**NSLPP MEETING HELD ON 01/02/2023****Attachments:**

ADDRESS/WARD: 12 Shellbank Parade, Cremorne**APPLICATION No:** DA 74/2022**PROPOSAL:** Partial demolition, alterations and additions to existing dwelling house, including a new garage and associated works.**PLANS REF:**

OWNER: Christopher Lyons Neville**APPLICANT:** Christopher Lyons Neville**AUTHOR:** Planning Ingenuity, Town Planning Consultants**DATE OF REPORT:** 23 January 2023**AMENDED:** 18 November 2022**DATE LODGED:** 15 March 2022**RECOMMENDATION:** Approval

Figure 11: Building height non-compliance

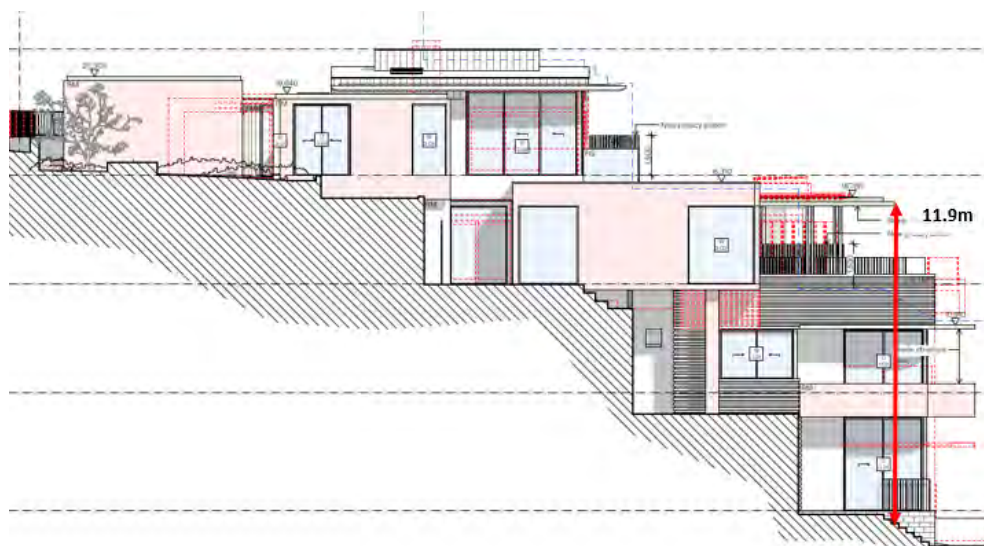
The proposed replacement shade structure/awning over deck 2 off the second floor living/dining area, at 11.9m above the existing ground level, would breach the LEP building height limit by up to 3.4m as shown in Figure 11 below.

Drawing Title
Site Plan

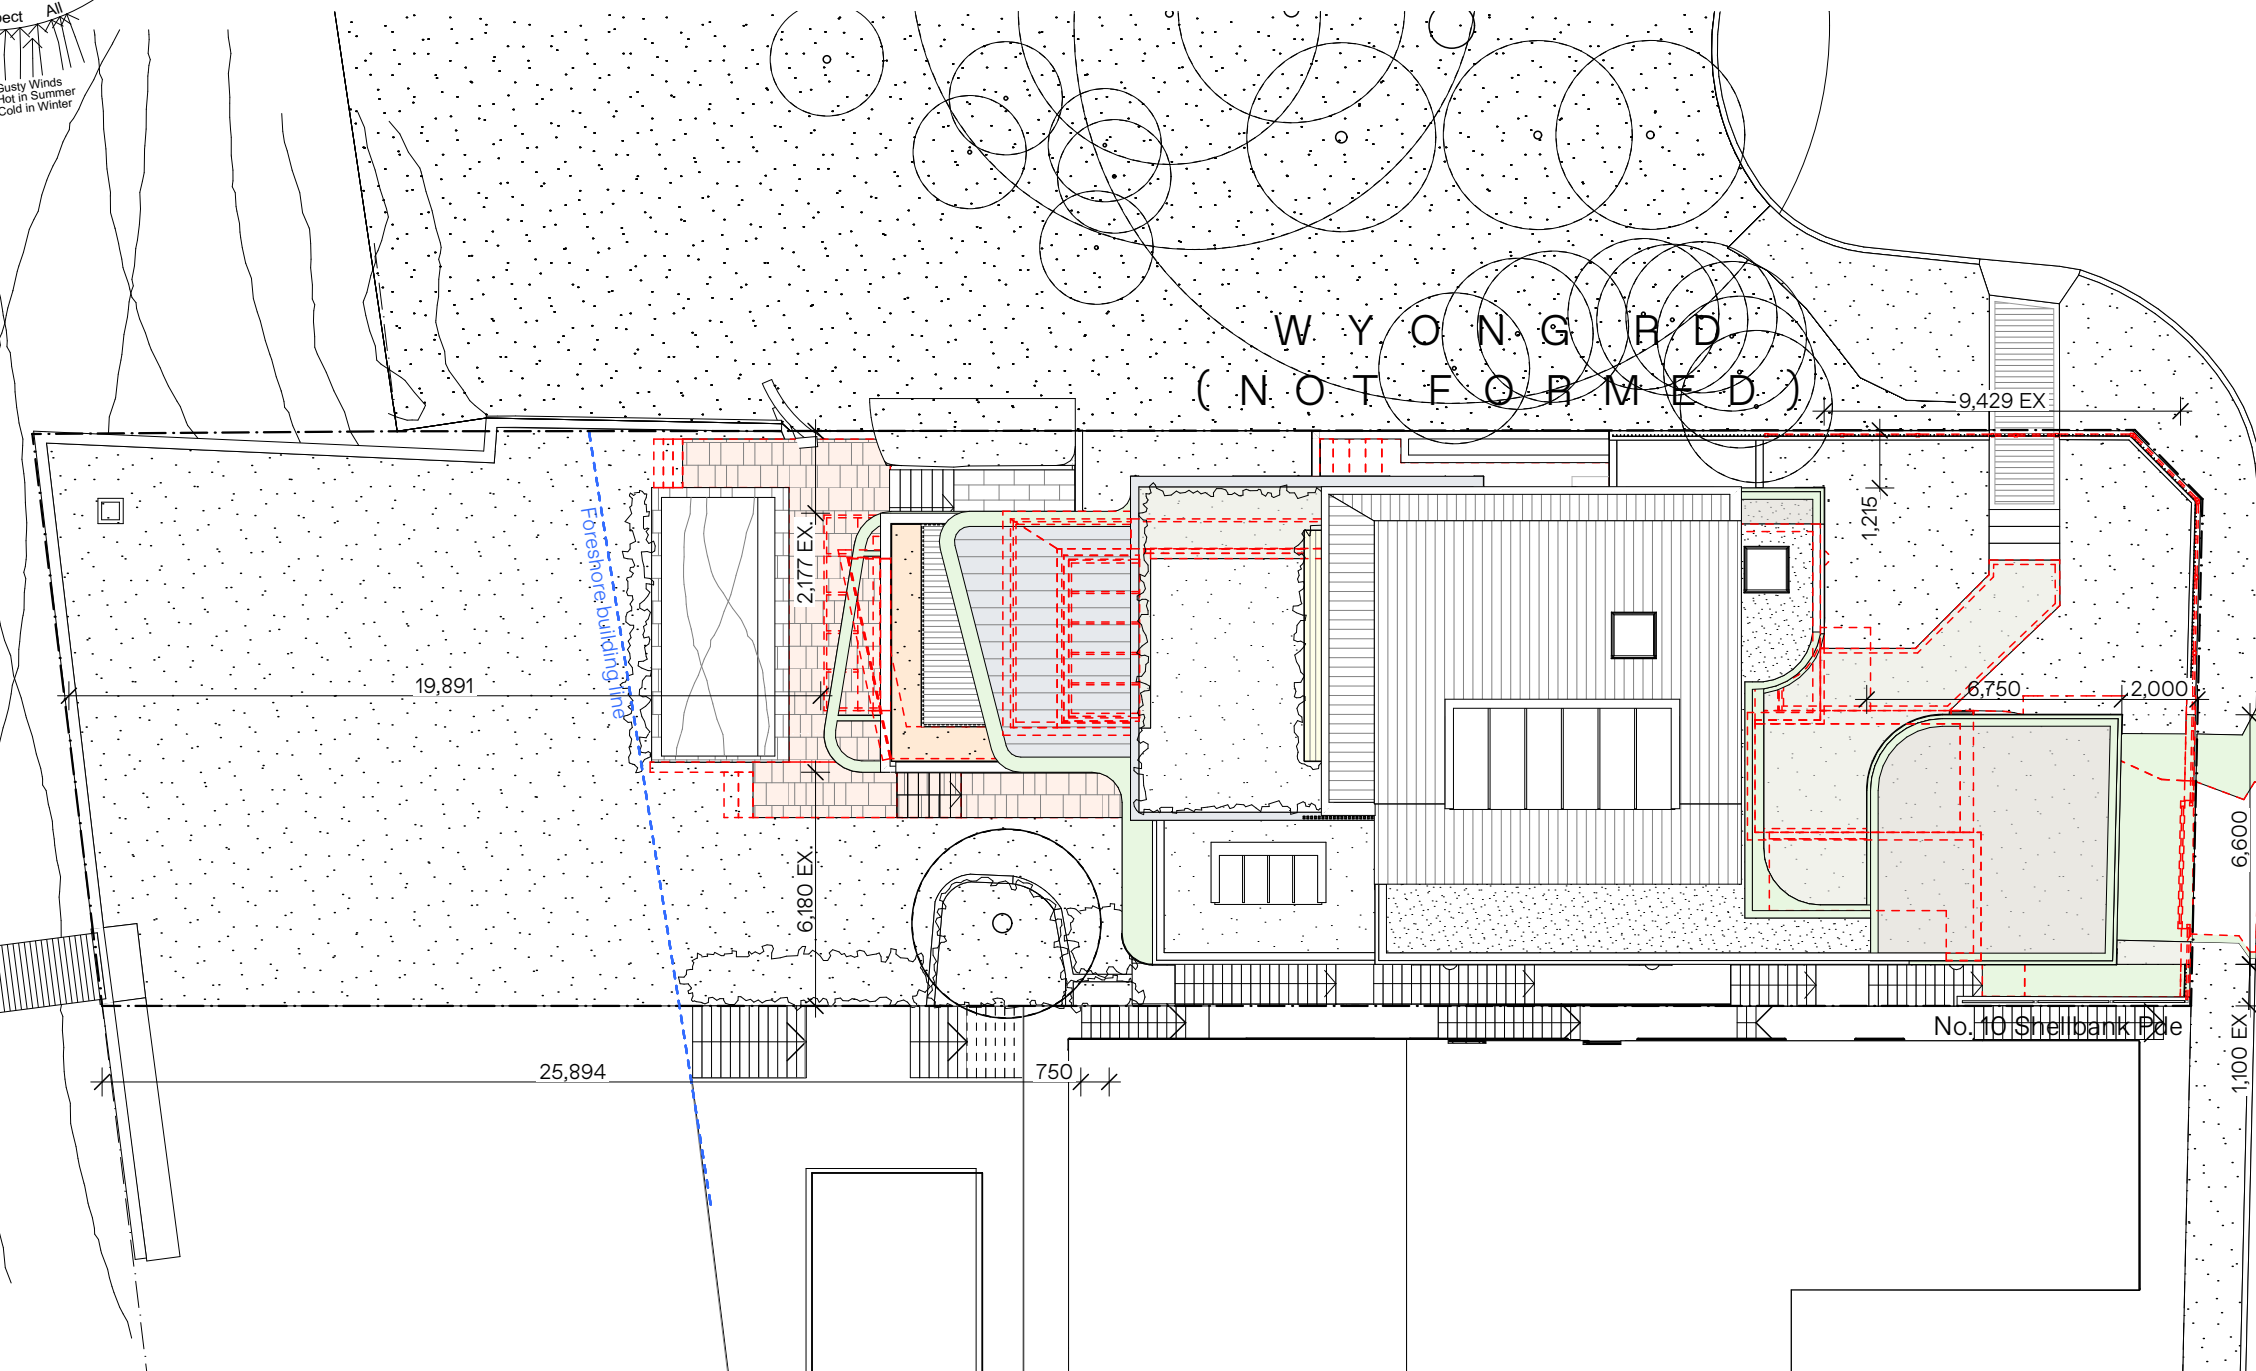
The proposed development, as amended by the applicant, will provide a 2m setback from the garage structure to the front boundary with Shellbank Parade. The proposed setback is considered appropriate and consistent with the character of development along Shellbank Parade, and will ensure vistas along the sites side boundaries are maintained. The garage will not create a visual barrier to the dwelling or vegetation within the front setback of the site, which will be retained.

- C2. The garage door shall provide a 250mm setback from the outer face of the external wall of the proposed garage structure on the street (Shellbank Parade) elevation.

Figure 1. Excerpt from North Elevation (Architectural Drawing 200 – North Elevation)

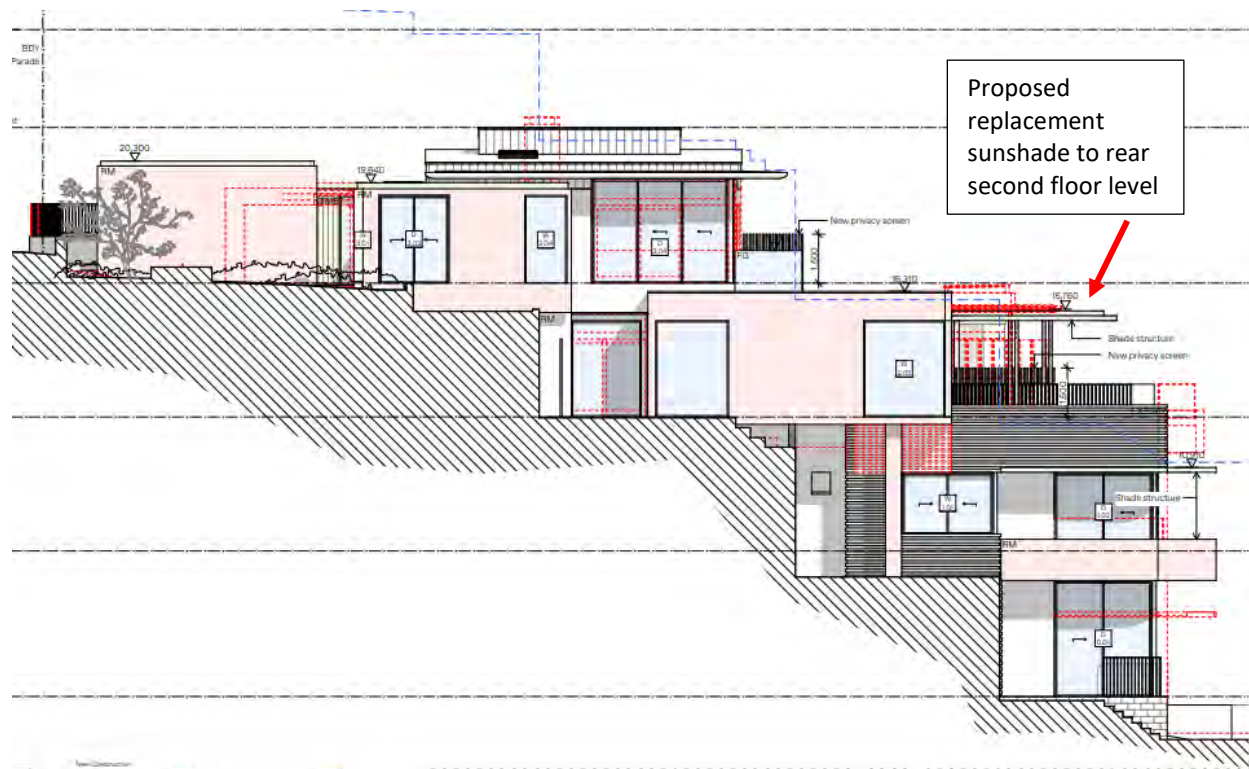
This results in a maximum building height to 11.9 metres on the south elevation (measured above the lowest landing to the external stair). See Figure 1 below. On the northern elevation this sunshade/roof measures 11.9 metres, which is lower (but projects slightly longer) than the existing canopy structure in this location. This component of the proposal also conforms to and reflects the natural landform, being an extension to an existing awning over an existing deck.

Figure 2. Excerpt from South Elevation (Architectural Drawing 202 – South Elevation)

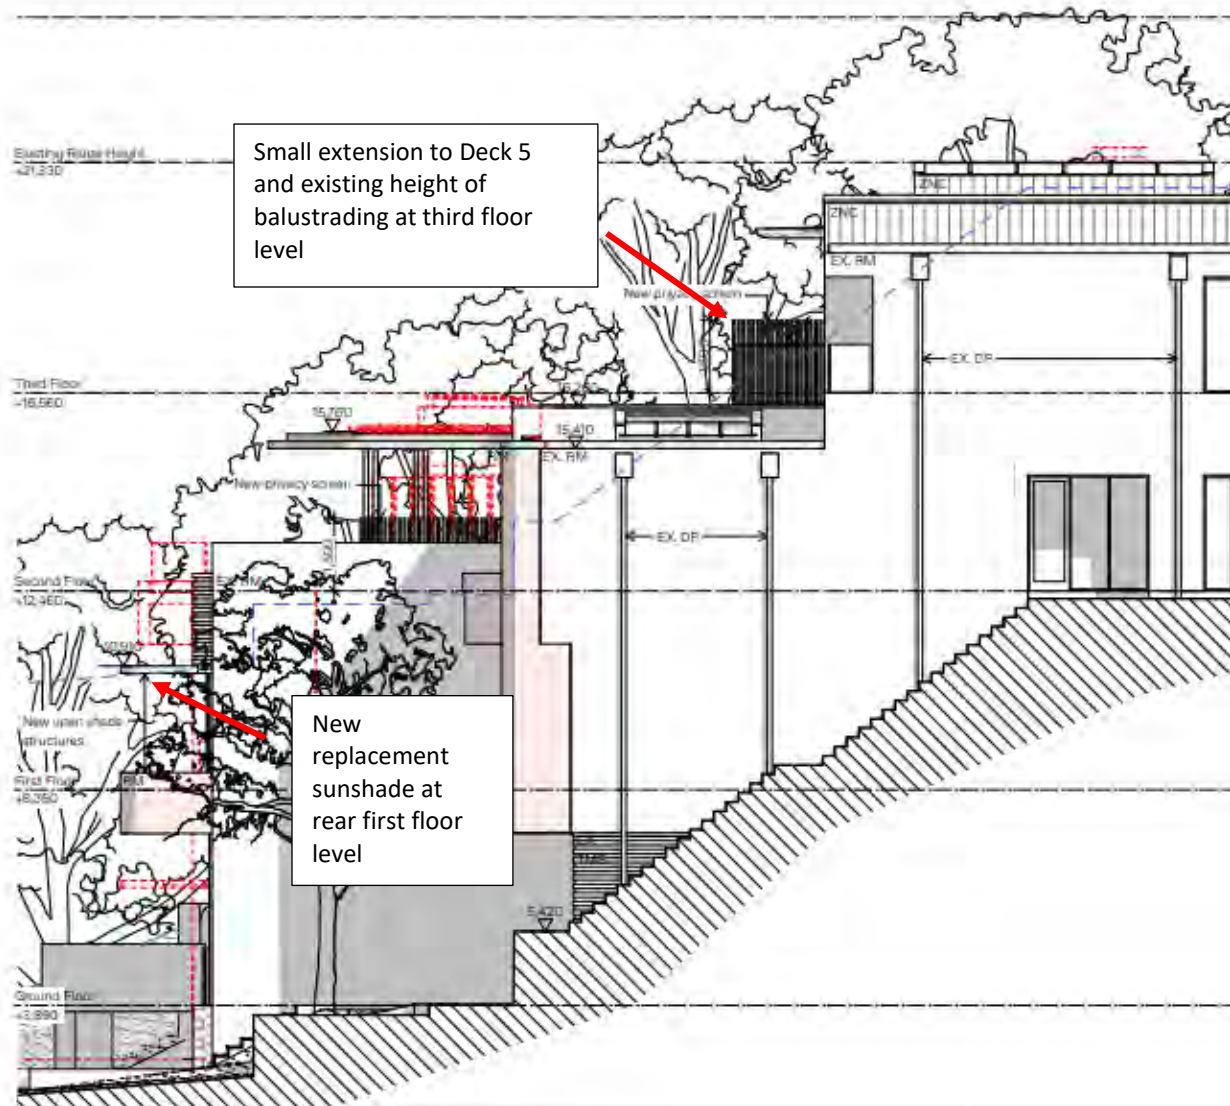
The proposal retains the maximum height of the existing balustrading of 9.130 metres (on the northern elevation). See Figure 2.
